Sicherheitsmitteilung

Nummer: **SM 2026-01 Aerodyne Icon Cutter Verlegung**

Technical Bulletin – AAD Cutter Placement

Bulletin: TB-250122

Figure 1.1

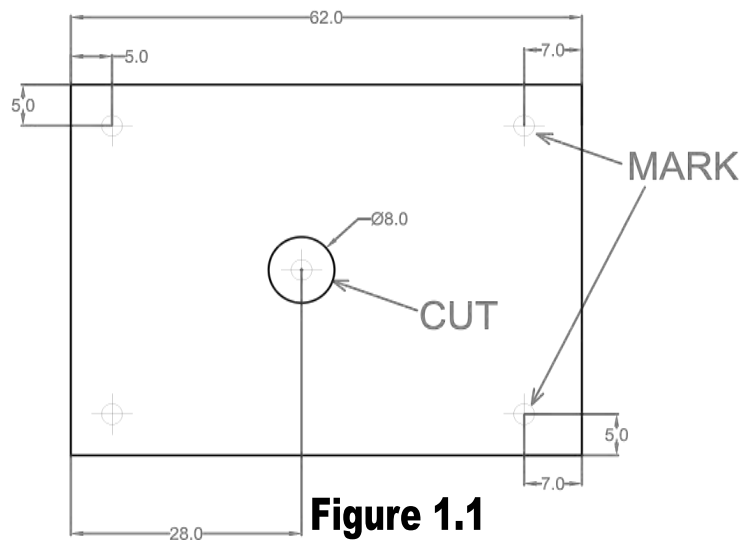
Cut a 62mm (+/- 2mm) length of Type 12 Webbing using a hot knife. Cut the hole using #0 grommet punch (do not hot knife hole!) and mark as shown in figures 1.1 and 1.2.

Figure 1.3

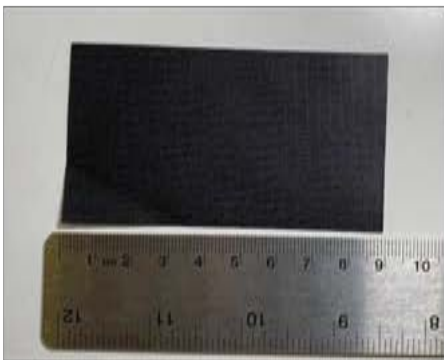
Cut a rectangle of 30D ZP Nylon Ripstop to 90mm x 50mm as shown in Figures 1.3 and 1.4.
